## ADDENDUM

PROJECT TITLE: Engineering Services – Charlotte Street (King Square South To Union Street) - Street Reconstruction And Traffic Light Installation	ADD. NO: 1
RFP NO: 2023-091001P	DATE: June 7 <sup>th</sup> , 2023
PAGE 1 of 2 (Including Confirmation Sheet)

Sanitary and Storm Sewer Video Limits

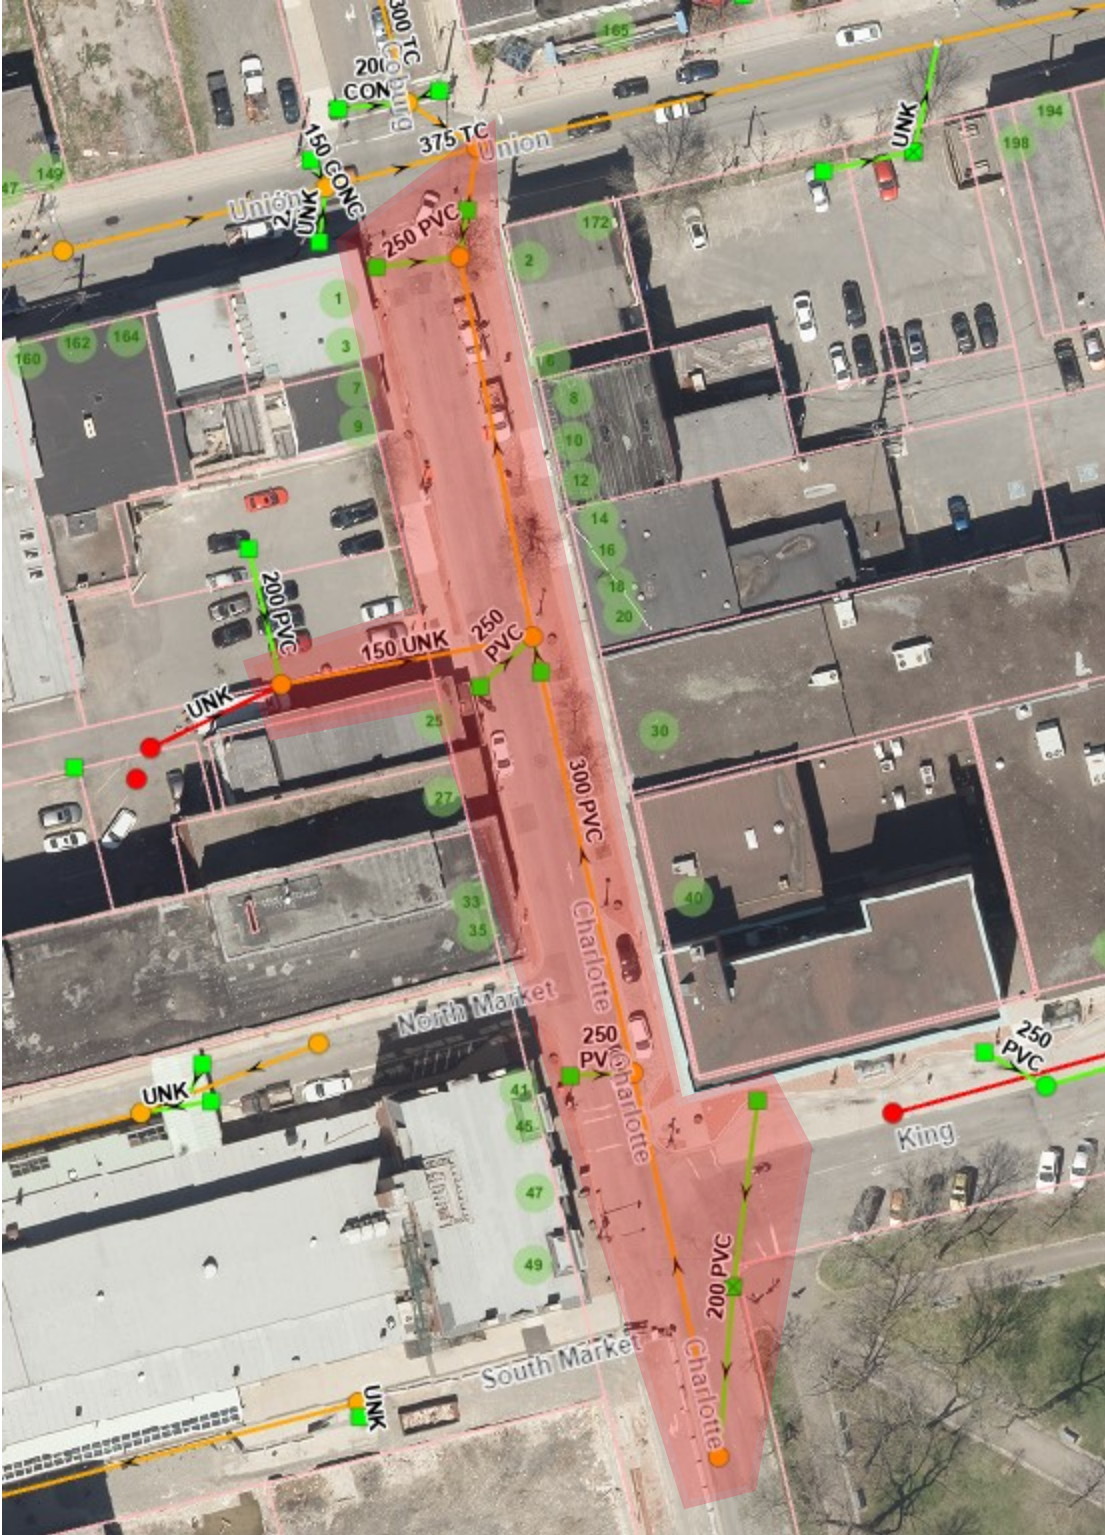
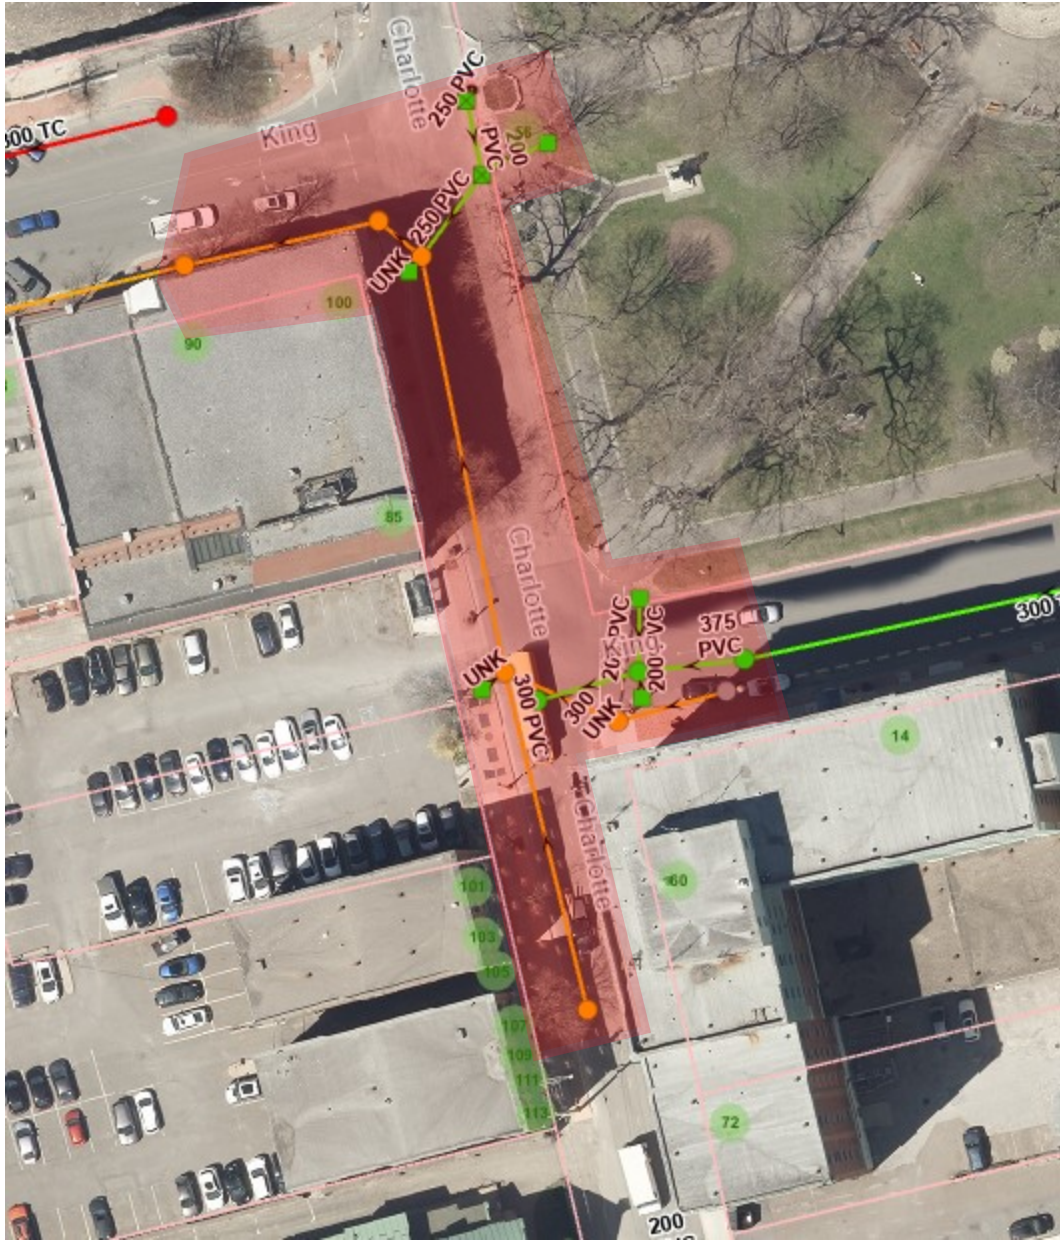
- Q3. Can a GIS Figure or approximate pipe lengths be provided outlining the storm and sanitary infrastructure that is required to be flushed and videoed?

- A3. See attached for a figure that shows the approximate limits for sewer flushing and videoing (highlighted in red).***
- Q4. Can the formula that is used to calculate the cost evaluation be provided?
